## Product Advisory (PA)

**Subject:** Correction of Manufacturing Part Number (MPN) Product Label to remove Pb-free designation symbol

**Publication Date:** 11/14/2023

Appendix B : Remove Pb-Free designation symbol

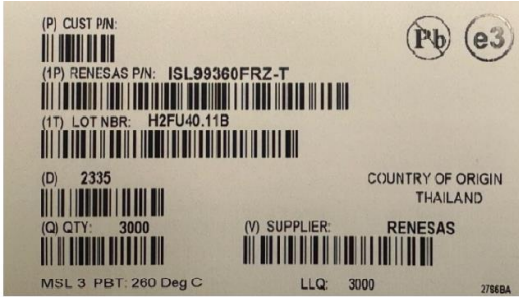
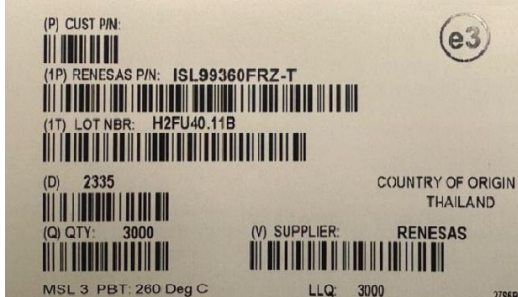
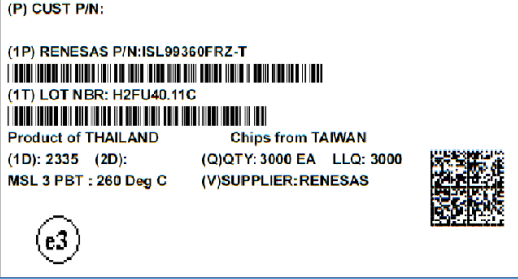
Details	Existing Label (From)	New Label (To)
<p>Shipping Label (Interior Label – 1D label)</p>	 <p>(P) CUST P/N:                  (1P) RENESAS P/N: ISL99360FRZ-T                  (1T) LOT NBR: H2FU40.11B                  (D) 2335 COUNTRY OF ORIGIN THAILAND                  (Q) QTY: 3000 (V) SUPPLIER: RENESAS                  MSL 3 PBT: 260 Deg C LLQ: 3000 2786BA</p>	 <p>(P) CUST P/N:                  (1P) RENESAS P/N: ISL99360FRZ-T                  (1T) LOT NBR: H2FU40.11B                  (D) 2335 COUNTRY OF ORIGIN THAILAND                  (Q) QTY: 3000 (V) SUPPLIER: RENESAS                  MSL 3 PBT: 260 Deg C LLQ: 3000 2786BA</p> <p>Pb-Free logo is removed.</p>
<p>Shipping Label (Interior Label – 2D label)</p>	 <p>(P) CUST P/N:                  (1P) RENESAS P/N: ISL99360FRZ-T                  (1T) LOT NBR: H2FU40.11C                  Product of THAILAND Chips from TAIWAN                  (1D): 2335 (2D): (Q) QTY: 3000 EA LLQ: 3000                  MSL 3 PBT : 260 Deg C (V) SUPPLIER: RENESAS</p>	 <p>(P) CUST P/N:                  (1P) RENESAS P/N: ISL99360FRZ-T                  (1T) LOT NBR: H2FU40.11C                  Product of THAILAND Chips from TAIWAN                  (1D): 2335 (2D): (Q) QTY: 3000 EA LLQ: 3000                  MSL 3 PBT : 260 Deg C (V) SUPPLIER: RENESAS</p> <p>Pb-Free logo is removed.</p>
